Tesla, Inc. Service Bulletin		<h2 style="margin: 0;">Install EMI Gasket to Reduce ASR-9 Radar Interference</h2>	
SB-20-17-001 January 02, 2020			
Classification		Section/Group	Mobile Service
Repair Bulletin		17 - Electrical	Model S, Model X (where permitted)
Model Year	Model	Country/Region	Version
2016 - 2019	Model S, Model X, and Model 3	All	All
<small>The model(s) and model year(s) listed are a general approximation of the affected VIN list. Refer to the VIN/Bulletin Tracker or Customer/Vehicle profile to determine applicability of this bulletin for a particular vehicle.</small>

When some Autopilot HW2 and HW2.5 Model S, Model X, and Model 3 vehicles are near airport ASR-9 radar antennae, the vehicle cameras might be affected by electromagnetic interference, and Autopilot/camera alerts might be displayed.

Upon customer complaint of Autopilot/camera alerts near airports, install an EMI gasket on the Autopilot ECU (Model S and Model X) or car computer (Model 3).

Figure 1

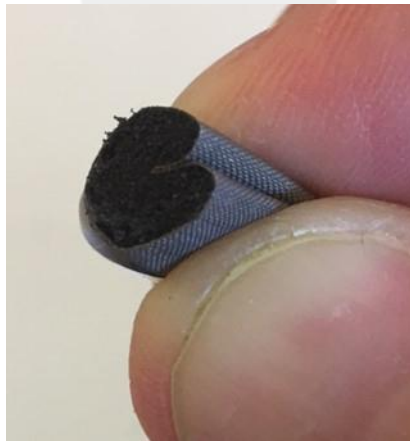
5. Fold the EMI gasket along its length to create a crease (Figure 1).

Figure 2 – Model S and Model X Autopilot ECU

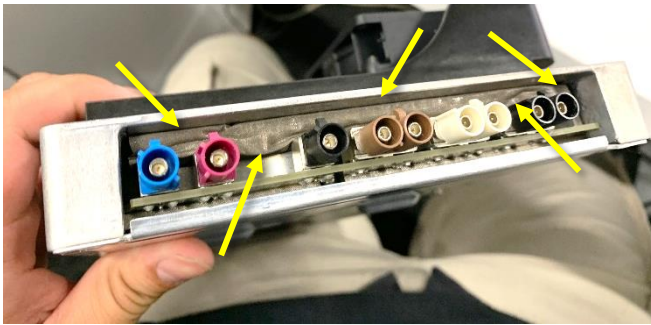
6. Use a plastic trim tool to press the gasket into the gap above the camera connectors of the Autopilot ECU (Model S and Model X) (Figure 2) or car computer (Model 3) (Figure 3).

NOTE: Make sure that the gasket material contacts the metal shielding on the camera connectors and the underside of the metal housing.
